# Access Compliance Report

## Public Rights-of-Way

### (Curb Ramps)

Intersection ID: 3920	Main Street: OVERLOOK_MOUNTAIN_DR	Cross Street: OVERLOOK_COVE_RD	Location: SW
ADA ID: 5EECC439B936	Ramp Type: Perp	Initial Pass/Fail: Fail	Overall Compliance: No
Codes/Mitigation Info/Possible Solution		Field Measurements/Component Compliance	
Severity Score: 33.75

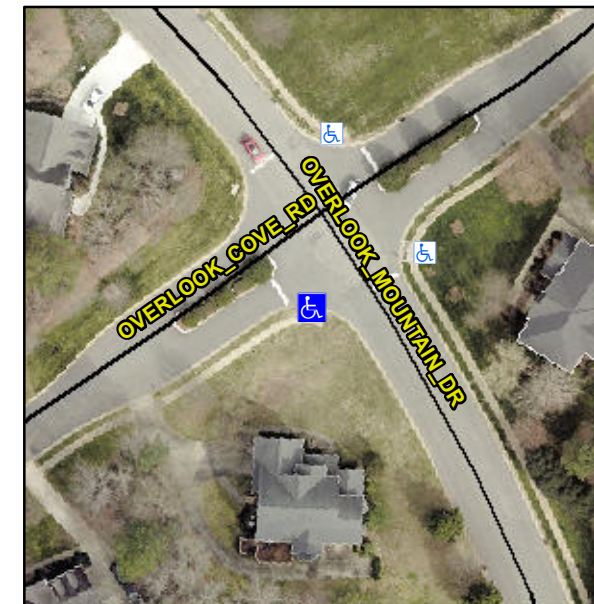
**R304.5.1, R304.5.3**

Compliance	Description	Data	Compliance	Description	Data
N/A	Ramp Length (in)	93.0	Yes	Ramp Slope (%)	5.6
No	Ramp Width (in)	44.0	No	Ramp XSlope (%)	10.7
N/A	Flare Type LT	N/A	N/A	Flare Type RT	N/A
N/A	Flare Slope LT (%)	N/A	N/A	Flare Slope RT (%)	N/A
N/A	Flare Traversable LT?	N/A	N/A	Flare Traversable RT?	N/A
N/A	Landing Length (in)	N/A	N/A	DWS Provided?	N/A
N/A	Landing Width (in)	N/A	N/A	DWS Contrast?	N/A
N/A	Landing Slope (%)	N/A	N/A	DWS Length (in)	N/A
N/A	Landing X Slope (%)	N/A	N/A	DWS Full Width?	N/A
N/A	Landing Curb? (Y/N)	N/A	N/A	DWS Offset (in)	N/A
N/A	Shared Landing?	N/A			
N/A	Gutter Ponding?	N/A	N/A	Gutter Slope (%)	N/A
N/A	Gutter Lip Ht (in)	N/A	N/A	Gutter X Slope (%)	N/A
N/A	Painted X Walk1?	No	N/A	Painted X Walk2?	N/A
	X Walk 1 Direction	To NE		X Walk 2 Direction	N/A
N/A	X Walk 1 Width (in)	N/A	N/A	X Walk 2 Width (in)	N/A
	X Walk 1 Slope (%)	2.5		X Walk 2 Slope (%)	N/A
	X Walk 1 X Slope (%)	7.3		X Walk 2 X Slope (%)	N/A

**Remove & Replace Entire Ramp.**
